Permit No: **PS-1503669**
Start Date: 01/07/2016
Exp. Date: 01/06/2017
APN No: 19327017

DRIVEWAY ENCROACHMENT PERMIT

Location: E/S HARLAN RD 5400' S/O MATHEWS RD

SHEET C2		SAN JOAQUIN COUNTY	
OF TWO		IMPROVEMENT AND STRIPING PLAN	
FILE 3469		C2	
JOB NO. 3469		EQUIPMENT COURT	
DATE: DEC. 2015		SCALE: AS SHOWN	
DRAWN: ZCW		DESIGN: MFI	
CHECKED: ZCW		DATE: 02/07/16

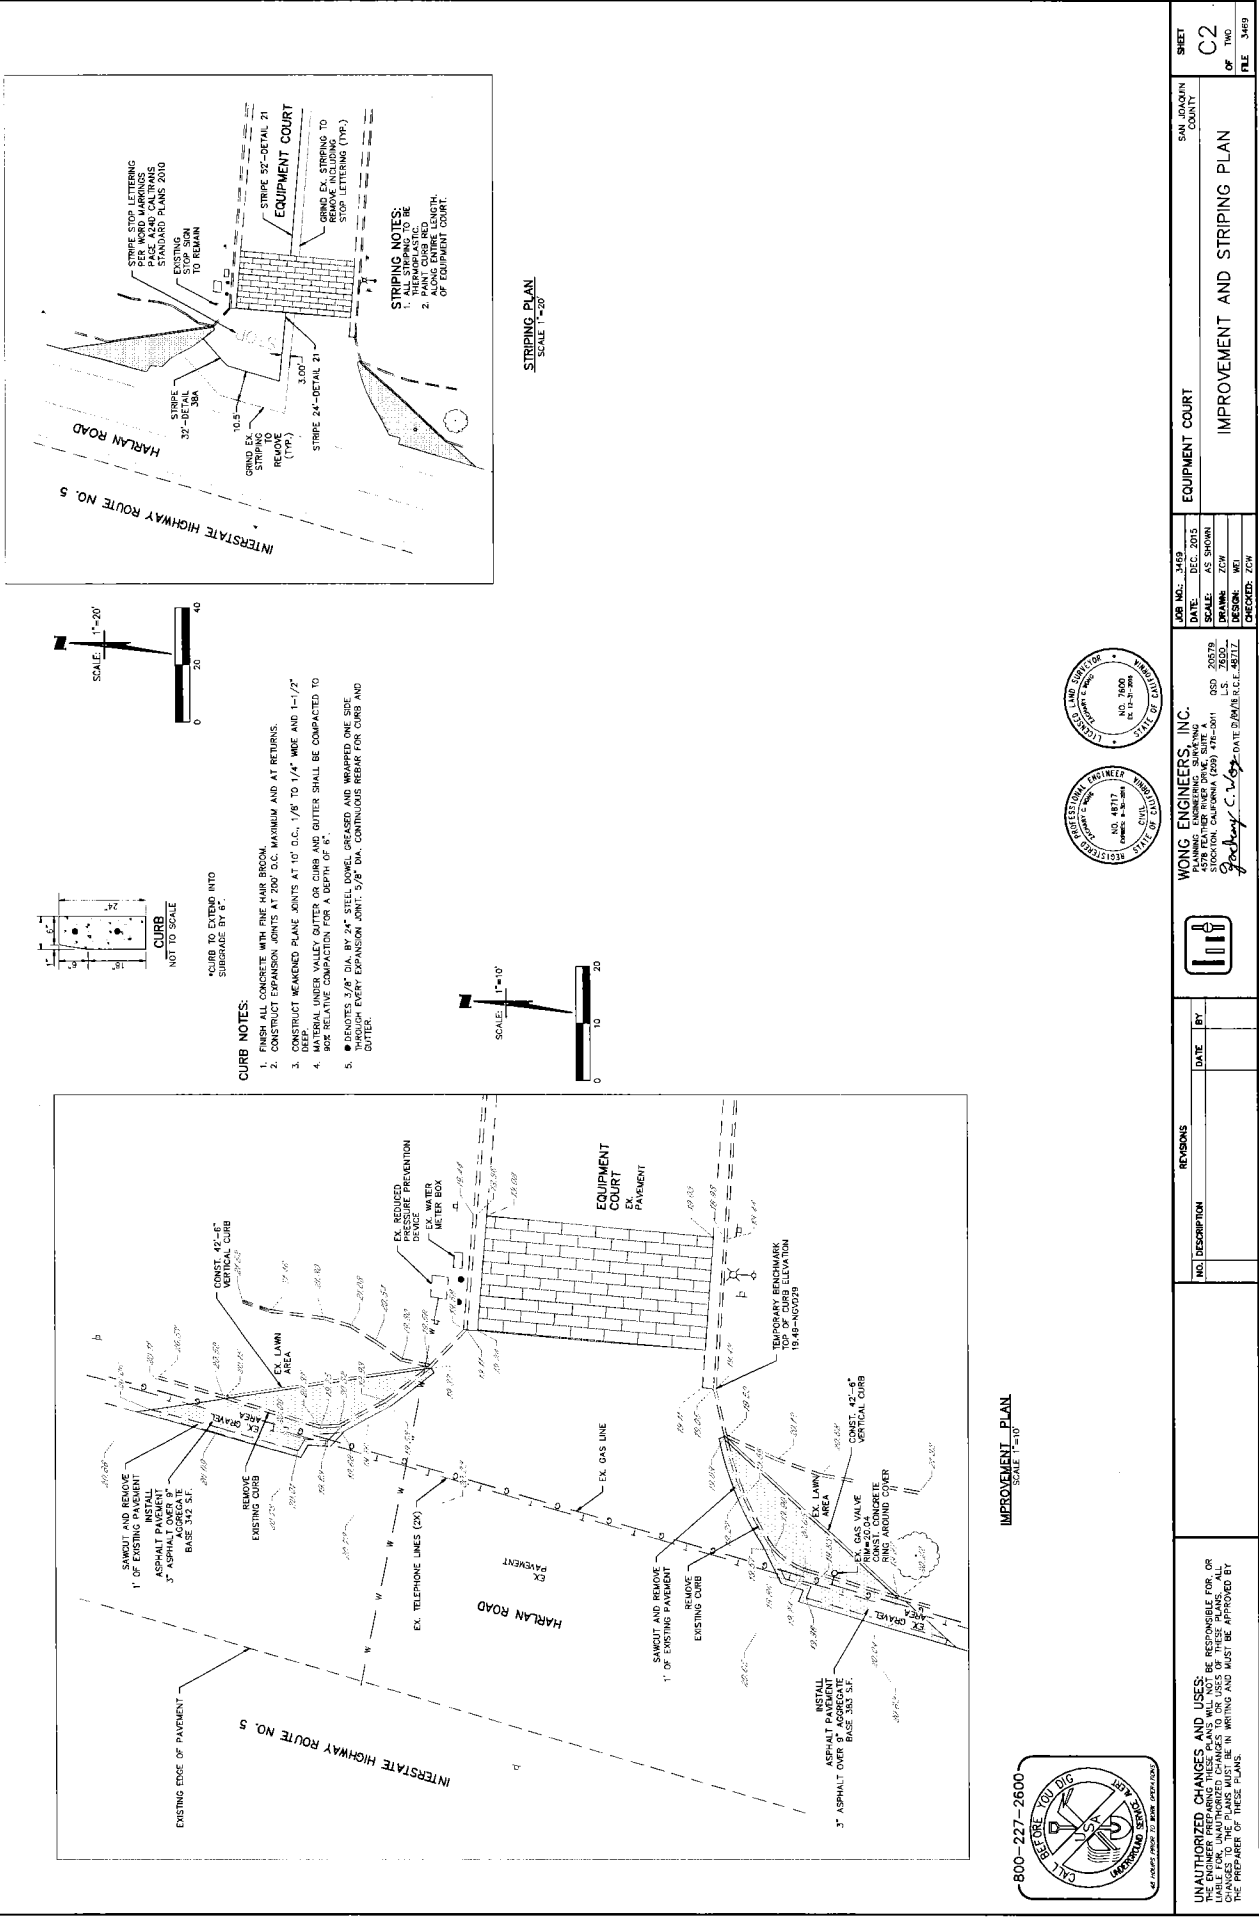
Just fyi...I am trying to get some info from our mapping dept. to confirm what this facility is because it's not on our current record map, but based on design drawings from 2008, it looks like plastic main was extended further north on Harlan Rd (past Equipment Ct) and I suspect this is a Electrolysis Test Station (test wires) used for locating purposes at what I believe is a steel to plastic transition (I don't think it's a valve).

Would this be acceptable for PG&E's gas valve?

Concrete ring should be fine.
